From: Planning Support
Subject: FW: HGY/2023/0313 and Richard Centre HGY/2023/0315

Re HGY/2023/0313--temporary classrooms:

Figure 7 Highgate school 1 in 100 years Storm Event. Flood Risk Assessment: Highgate Sch Surface Water Modelling Report. Edenvale modelling report (May 2019)

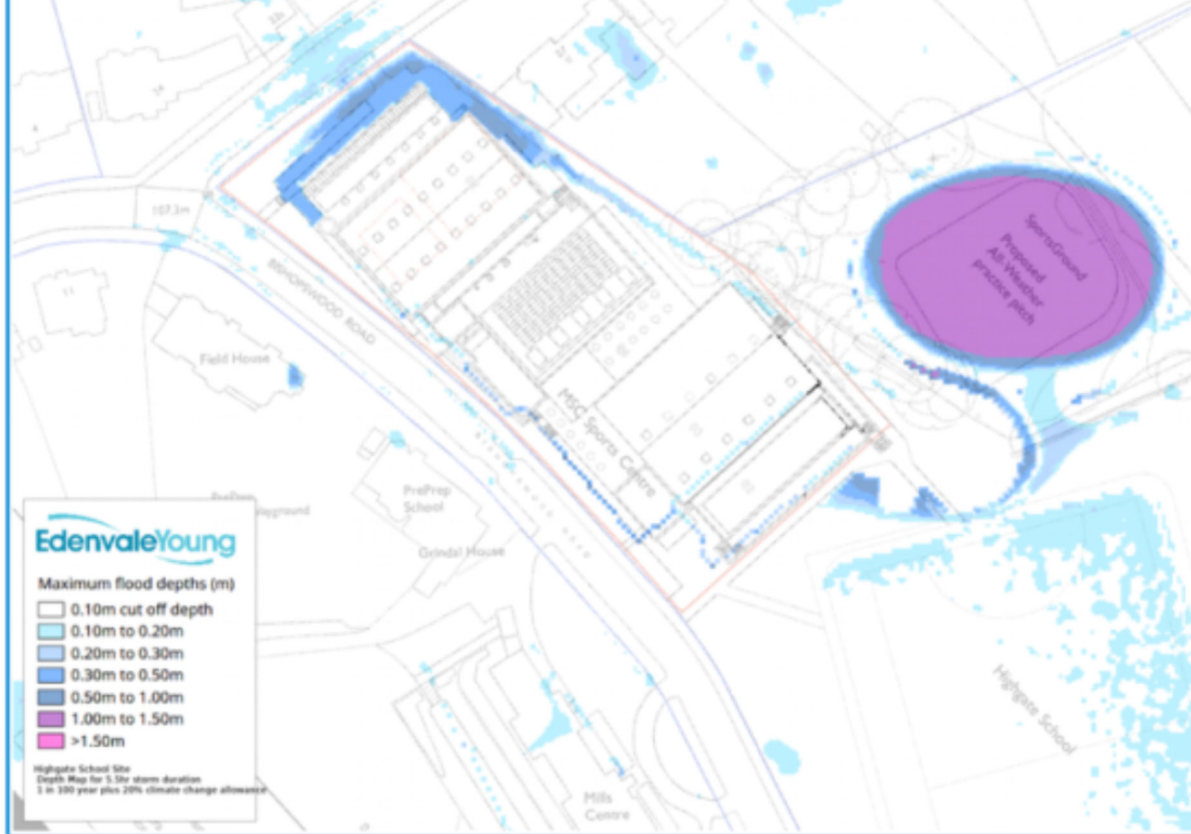
2. The flood risk assessment for the temporary classrooms produced by Peter Deer and Associates, includes figure 7 (attached) which seems to show the extent of flooding as taken from EdenvaleYoung report, but the EdenvaleYoung report did not include the temporary class rooms in their model, so the use of the EdenvaleYoung data is not appropriate. Also Figure 7 does not show the flood risk for the area covered by the temporary class rooms, just a section of the temporary classrooms, which is really odd.

3. The flood risk assessment for the temporary classrooms produced by Peter Deer and Associates and their figure 7 seems to show a different flood outline for the "oval" basin, which is no longer an "oval". So has the FRA for the sports centre been re-issued or amended by EdenvaleYoung?

The flood risk assessment for the temporary classrooms produced by Peter Deer and Associates and their figure 7 seems to show a different flood outline for the “oval” sports pitch/flood basin, which is no longer an “oval”. So has the Flood Risk Assessment for the sports centre been re-issued or amended by EdenvaleYoung? And if so, can we have the details?
